RE: Project # Z-962-20 / AN-258-20 / ECAGID-15-20

The initial submittal of the materials associated with the proposed Quick Trip rezoning to Planned Unit Development, annexation, and inclusion in the General Improvement District was reviewed by staff and referral agencies. The resulting comments and comment letters provide feedback for a resubmittal of the plans. Please note that as of the time of this communication, the project has not yet been presented to the Development Review Team (DRT) due to project pipeline issues and a delay in review feedback from critical agencies/departments. We will be discussing the project with the DRT on December 3rd and relaying additional information. Further, when other formal comments arrive, we will provide those to you immediately. We would ask that you refrain from resubmittal until complete feedback from those critical agencies/departments is received.

Rezoning/PUD comments - Z-962-20

TO: Travis Reynolds, Planner
FROM: Lindy Howard, P.E., Consulting Development Review Engineer
DATE: March 1, 2021
SUBJECT: Z-962-20-21 (rezoning to PUD), AN-258-20 (Annexation), ECAGID-015-20 (Inclusion in the E-470 Inclusion Area GID) - SWC East 81st Ave an

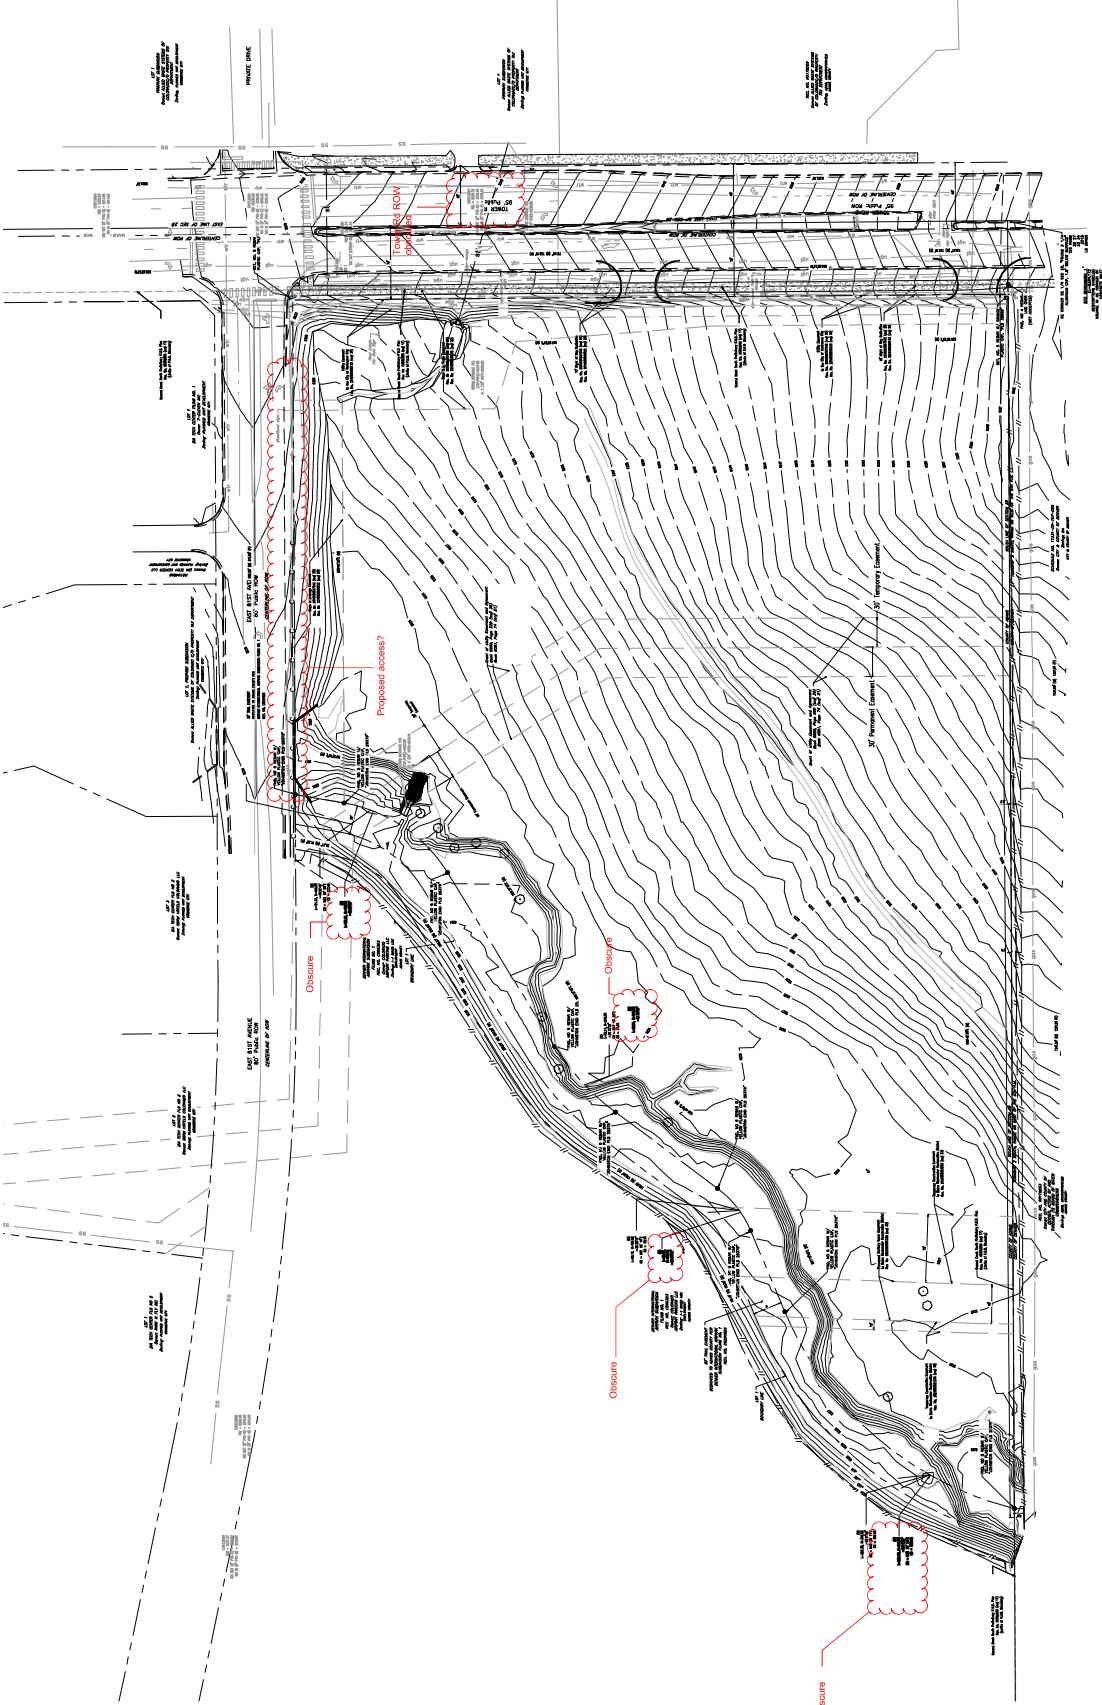
Fix language

Please break into additional quarters, etc...

Please in list or table.

Please change to Code Development

QUIKTRIP PUD ZONE DOCUMENT

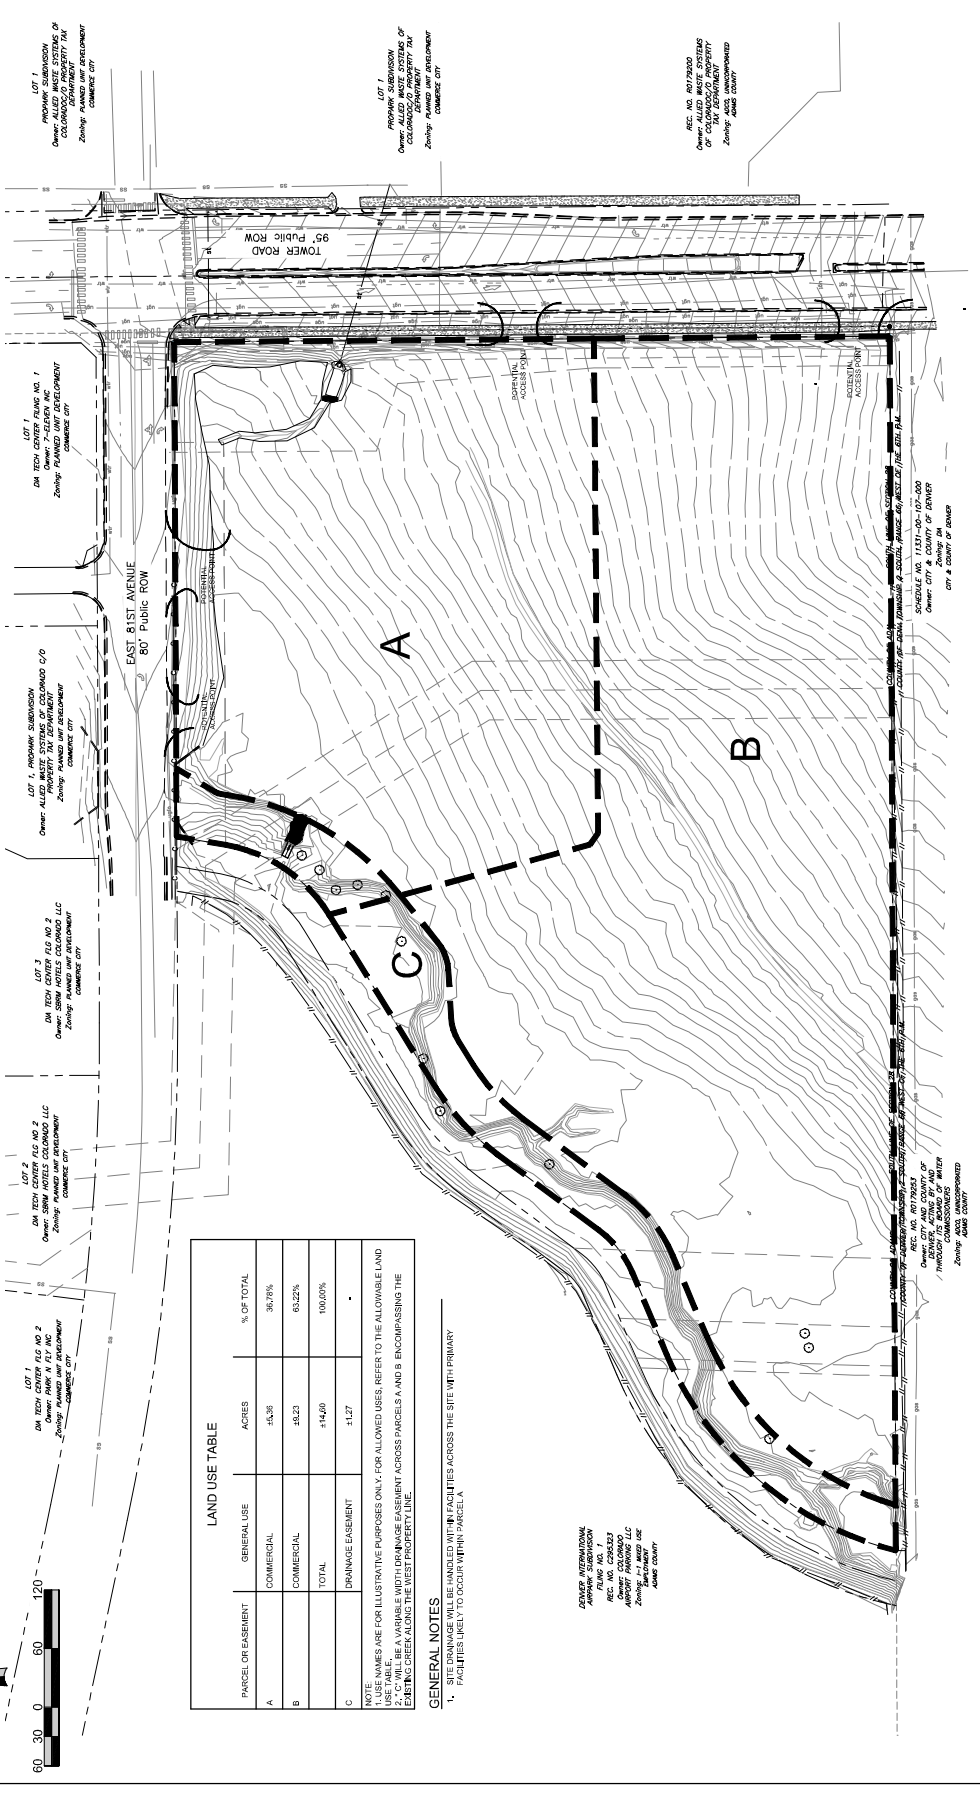
☐ Comments related to PUD Zone Document Sheet 3:

- 4) The General Notes on this Sheet and Sheet 4 need to be in one place and combined.
- 5) For General Note #2, please update to 15% modification.
- 6) For General Note #1, I will be looking for some examples of Design Standards for you to assist as you work on creating some for this development.

- 7) For General Note #1, please insert "approval" to read, but prior to PUD Permit **Approval** or construction on site.
- 8) Please remove the Note in the bottom right corner, as that does not apply.

SHEET NUMBER:
1 OF 5

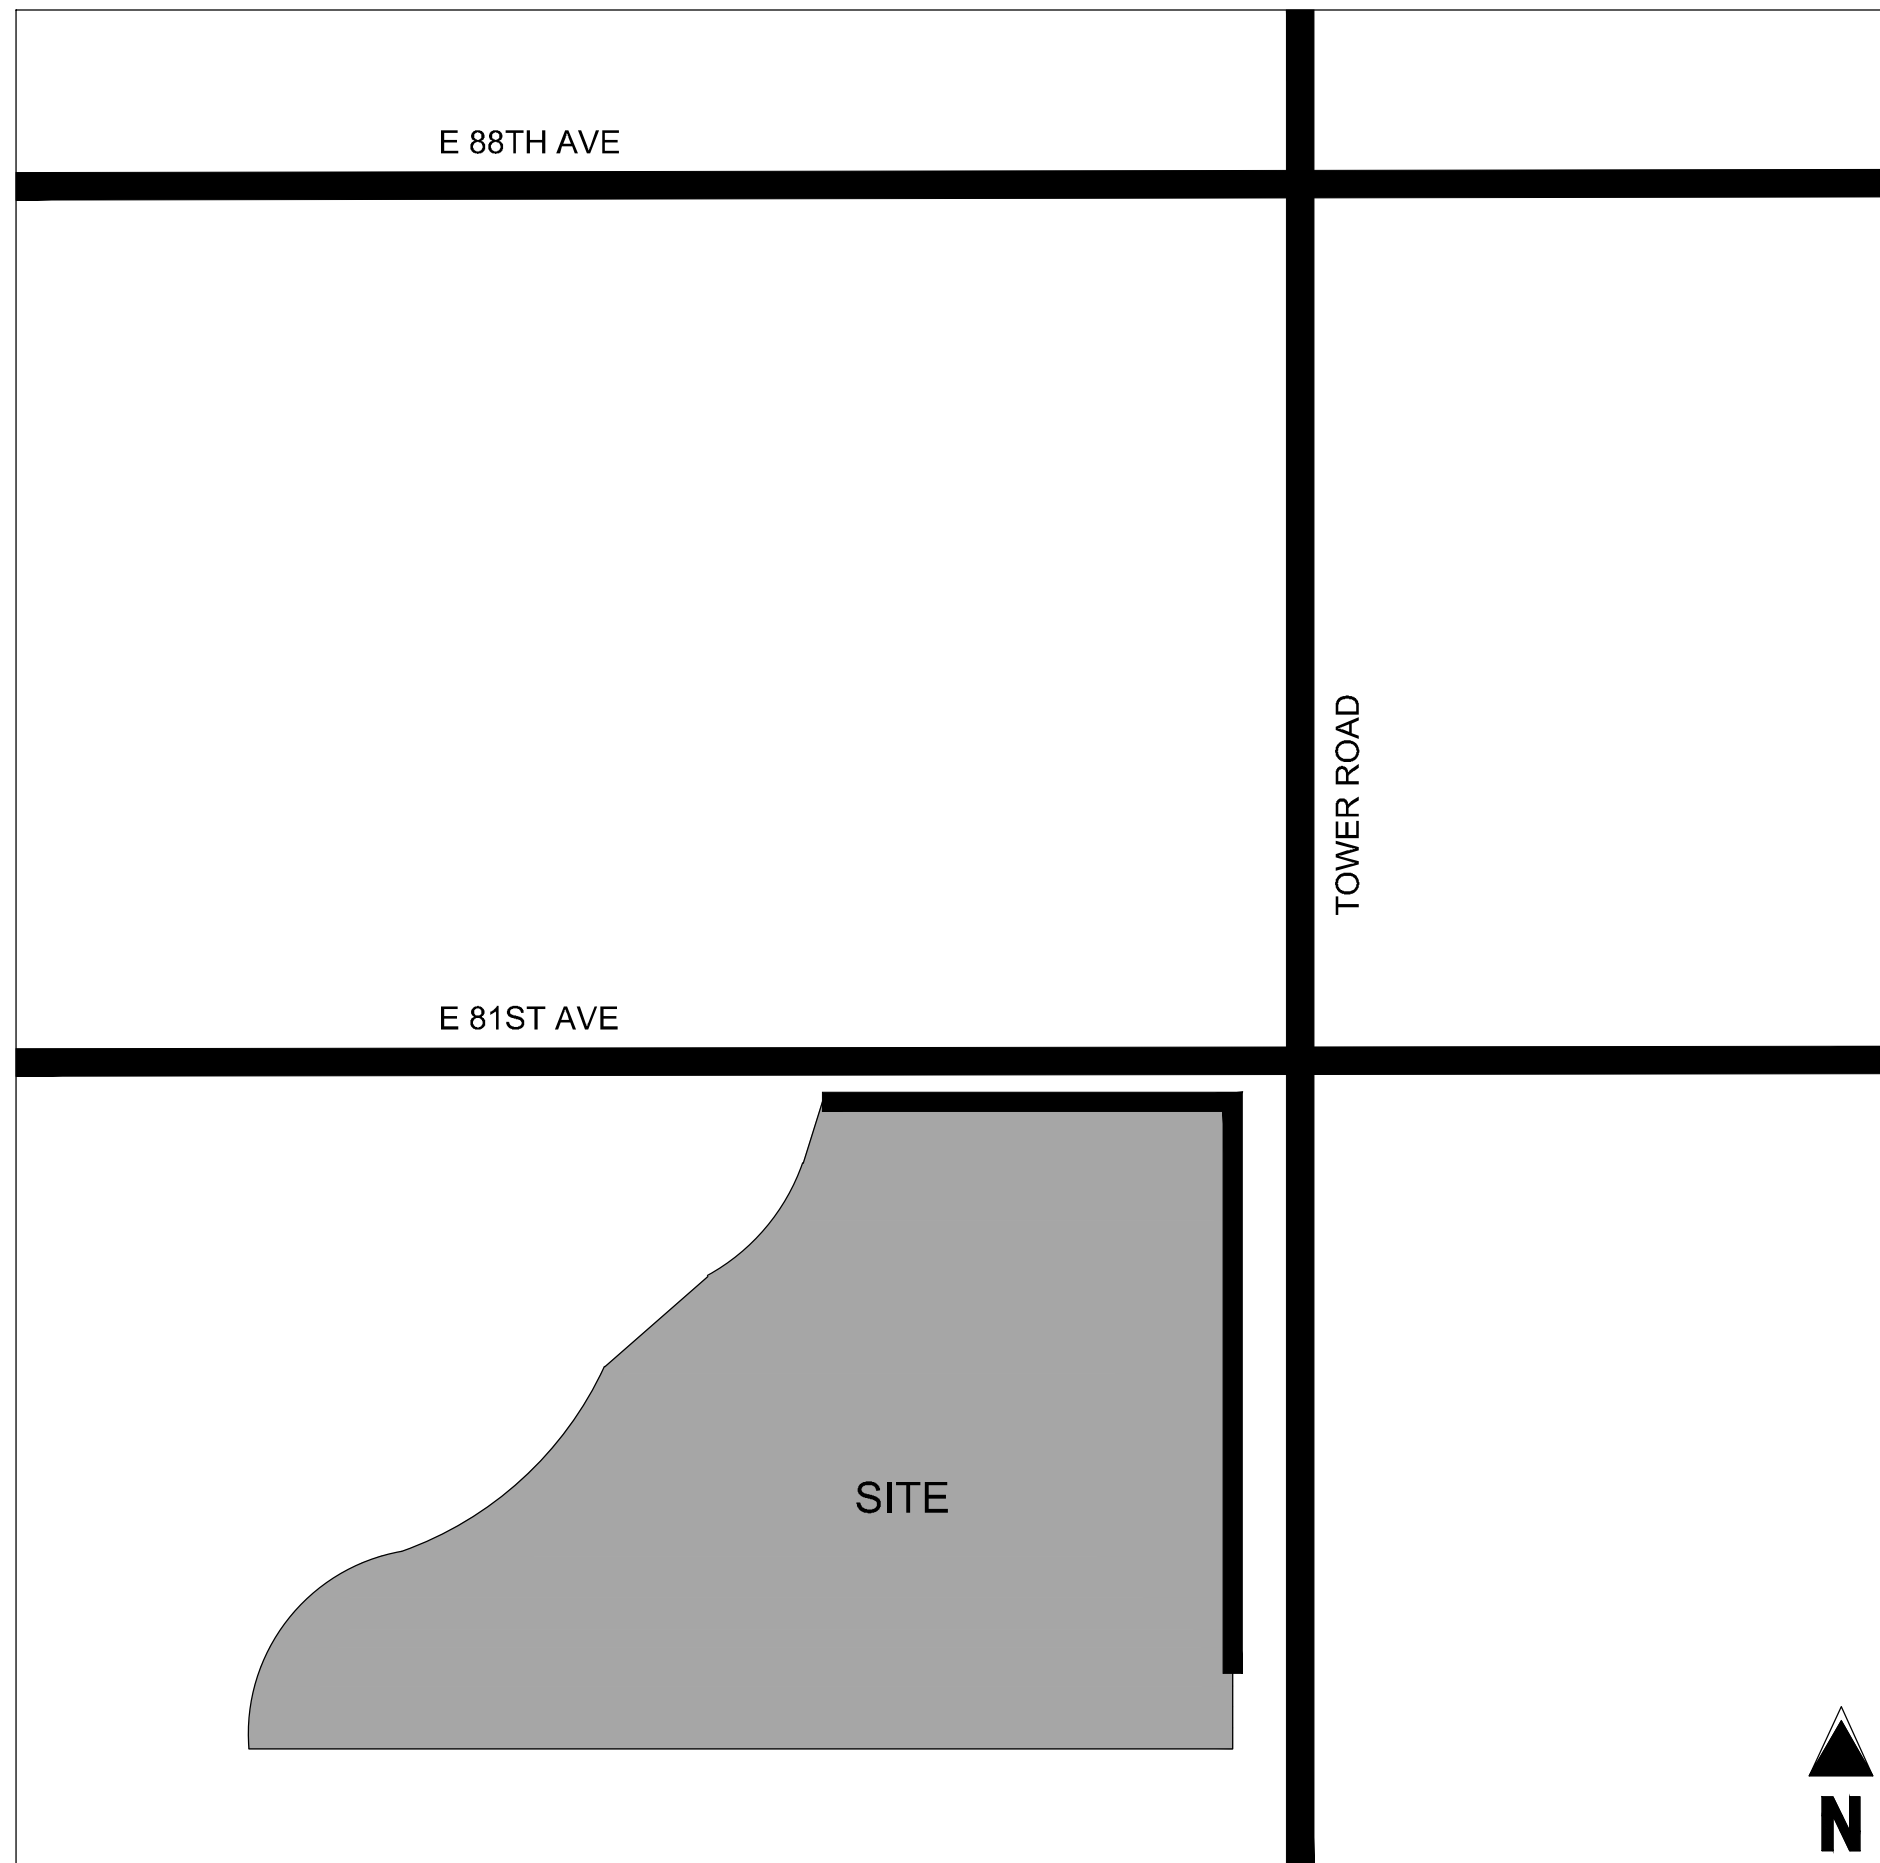
Comments related to PUD Zone Document Sheet 1:

- 1) For formatting, please move the ownership certificate to the far left column at the bottom. The planning commission and city council certificates can remain in the far right column.
- 2) For formatting, please move the project location, sheet index, technical consultants, etc. to the middle bottom column.
- 3) Typo on date of preparation, not preparation.
- 4) Please remove the Z-962-20 from the reception number in the bottom right corner. Adams County will fill that field in with their own reception number once recorded.
